Well Name: NEWSOM C	Well Location: T26N / R8W / SEC 22 / NENW / 36.477156 / -107.671368	County or Parish/State: SAN JUAN / NM
Well Number: 2	Type of Well: CONVENTIONAL GAS WELL	Allottee or Tribe Name:
Lease Number: NMSF078384	Unit or CA Name:	Unit or CA Number:
US Well Number: 3004505775	Well Status: Gas Well Shut In	Operator: HILCORP ENERGY COMPANY

Notice of Intent

Type of Submission: Notice of Intent	Type of Action: Plug and Abandonment
Date Sundry Submitted: 01/26/2022	Time Sundry Submitted: 12:51
Date proposed operation will begin: 02/01/2022

Well: Newsom C 2

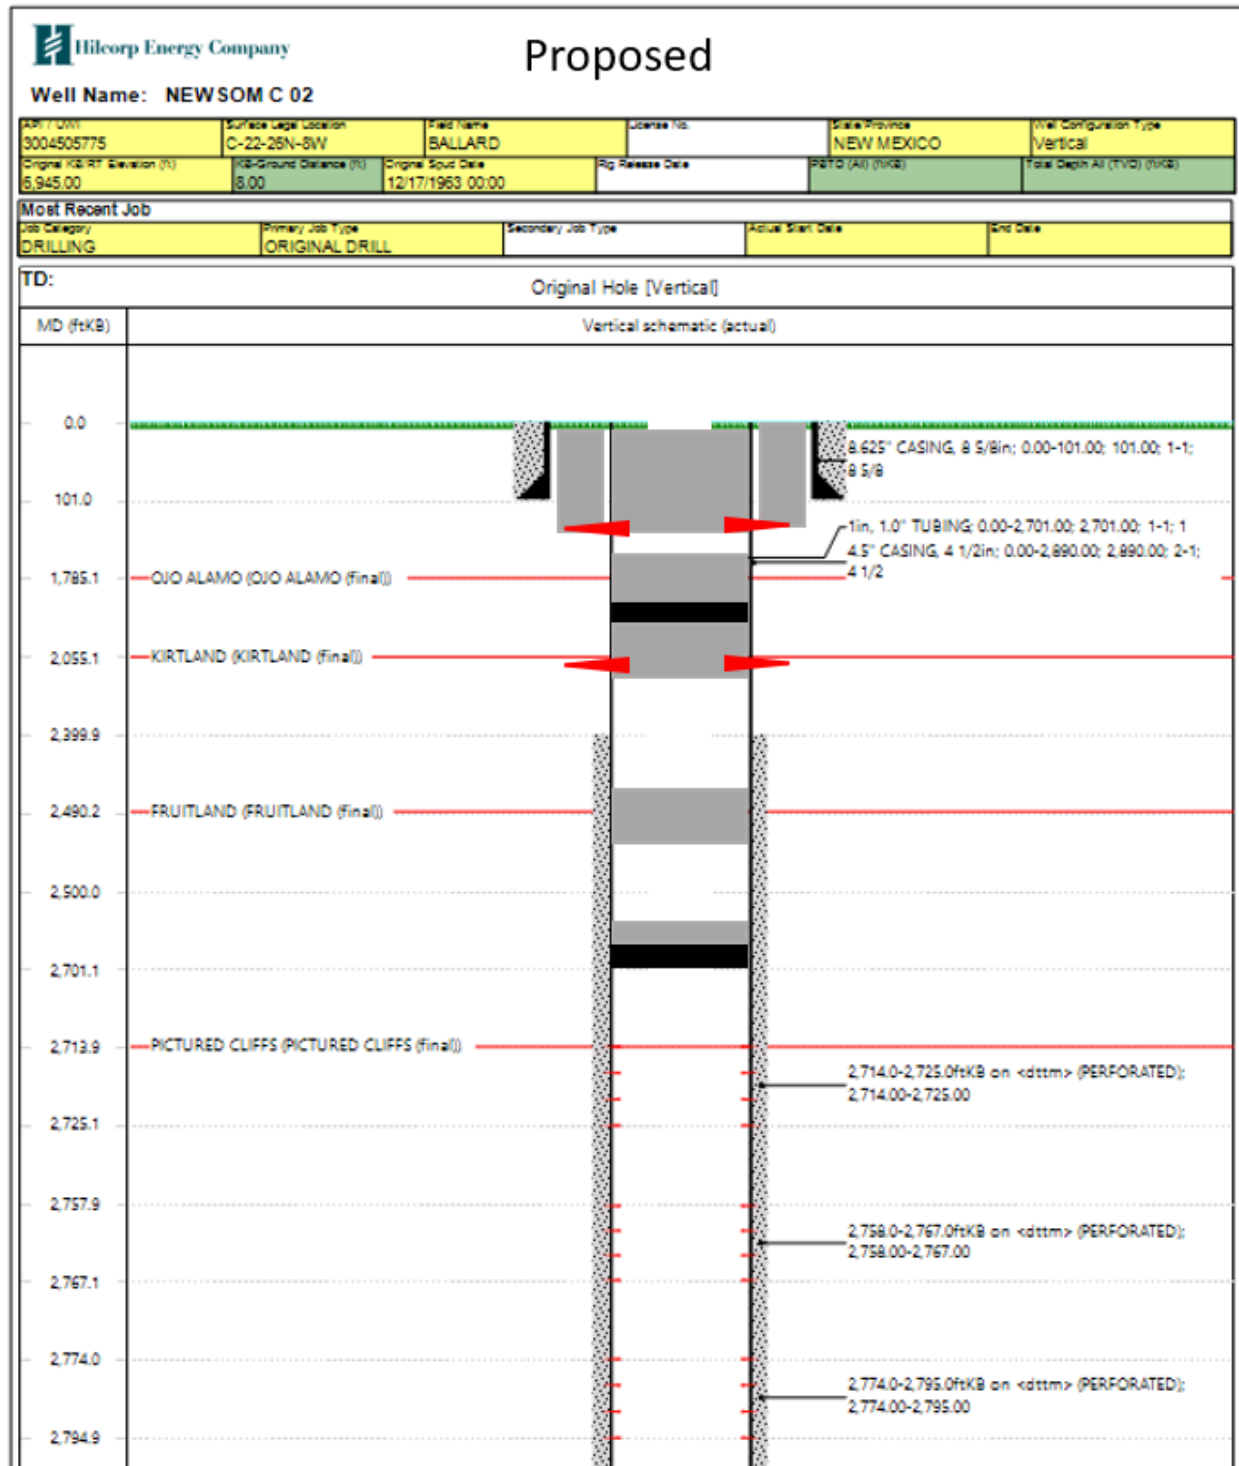
1. Plugging operations authorized are subject to the attached "General Requirements for Permanent Abandonment of Wells on Federal and Indian Lease."
2. The following modifications to your plugging program are to be made:
 - a) Increase the volume of cement above Plug #1 (Pictured Cliffs) to 50' of cement on top of the CIBP.
 - b) Bring the top of Plug #2 (Fruitland) up to 2358' to cover BLM formation top pick.
 - c) Bring the bottom of Plug #3 (Kirtland, Ojo Alamo) down to 2128' to cover BLM formation top pick for the Kirtland.
 - d) Add a plug, or bring the bottom of Plug #3 (Surface) down to 320', to cover BLM formation top pick for the Nacimiento.
3. Farmington Office is to be notified at least 24 hours before the plugging operations commence at (505) 564-7750.

- BLM picks for the Fruitland, Kirtland, Ojo Alamo and Nacimiento formation tops vary from Operator.
- Bring the top of Plug #2 (Fruitland) up to 2358' to cover BLM formation top pick.
- Bring the bottom of Plug #3 (Kirtland, Ojo Alamo) down to 2128' to cover BLM formation top pick for the Kirtland.
- Add a plug, or bring the bottom of Plug #3 (Surface) down to 320', to cover BLM formation top pick for the Nacimiento.
- The plugs proposed in the P&A procedure, with recommended changes, will adequately protect any freshwater sands in this well bore.
- Pictured Cliffs perms 2714' – 2795'.
